PIC24F16KA102 Family Silicon Errata and Data Sheet Clarification

The PIC24F16KA102 family devices that you have received conform functionally to the current Device Data Sheet (DS39927B), except for the anomalies described in this document.

Data Sheet Clarifications

The following typographic corrections and clarifications are to be noted for the latest version of the Device Data Sheet (DS39927B):

FIGURE 1: PIN DIAGRAMS

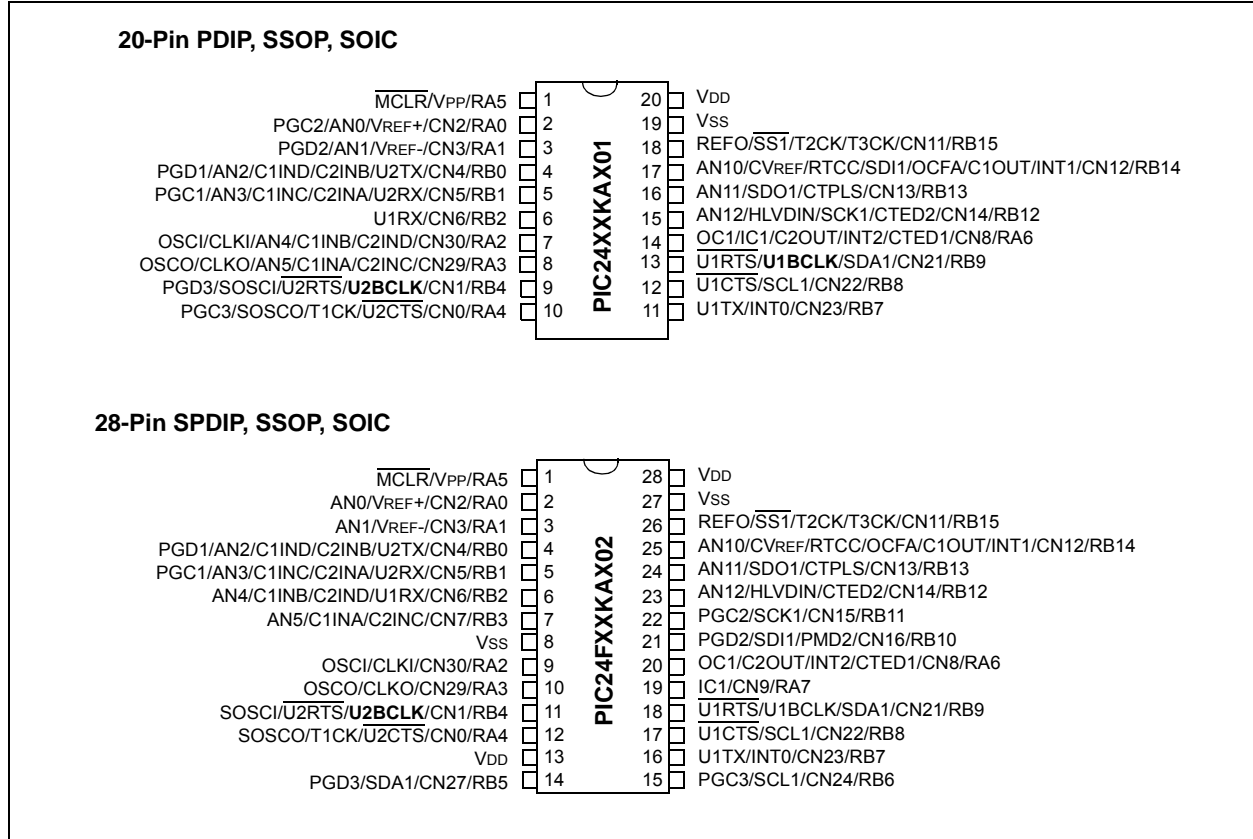
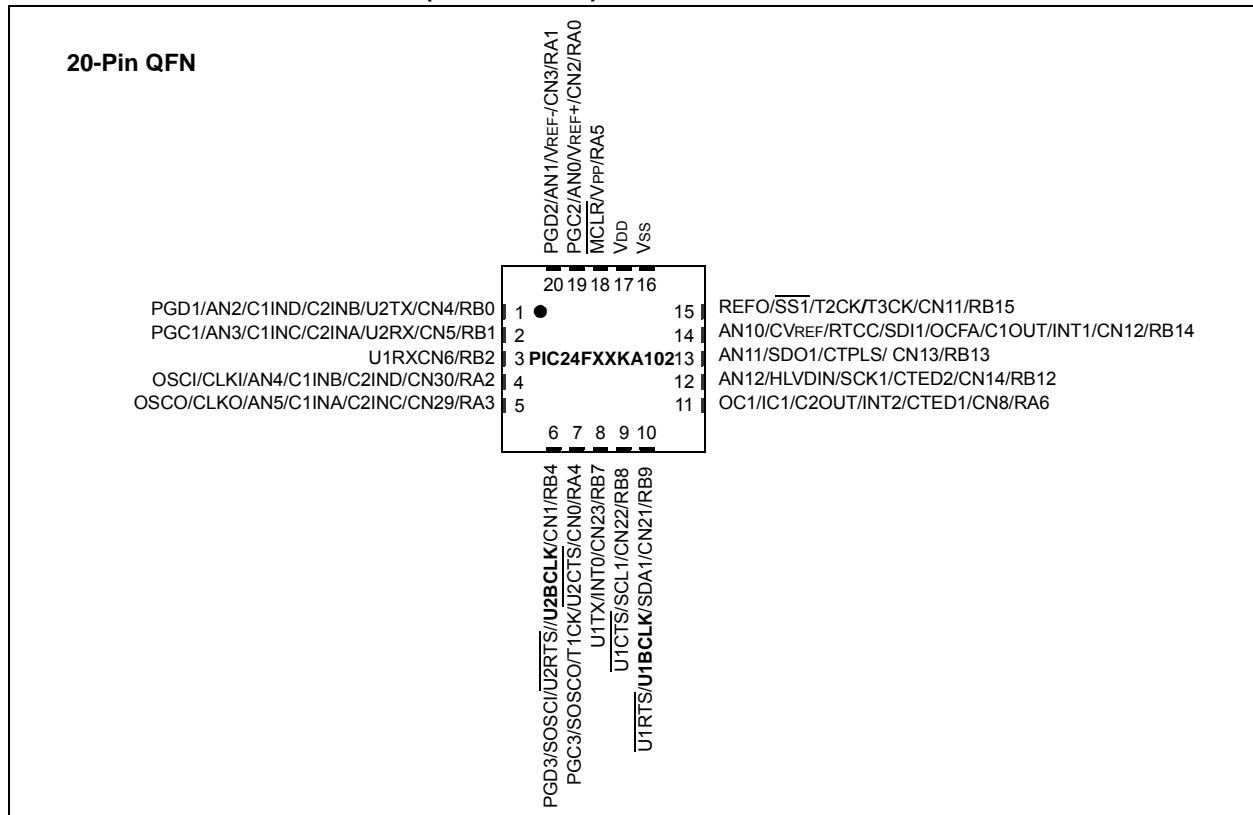
8. Module: Pin Diagrams

In many places in the data sheet, the UART Baud Clock output functions, U1BCLK and U2BCLK, are shown as being multiplexed on the same pins as the UART Receive input functions (U1RX and U2RX). The Baud Clock is actually multiplexed with the UART Ready-to-Send output function (U1RTS and U2RTS) on completely different pins. This mapping is correctly described in the UART chapter, but incorrectly shown on pin diagrams and pin function listings.

The pin diagrams from the data sheet are replaced by the pin diagrams shown in [Figure 1](#), [Figure 2](#) and [Figure 3](#). Changes are noted in bold. Footnotes present in the original diagrams have been omitted here for clarity.
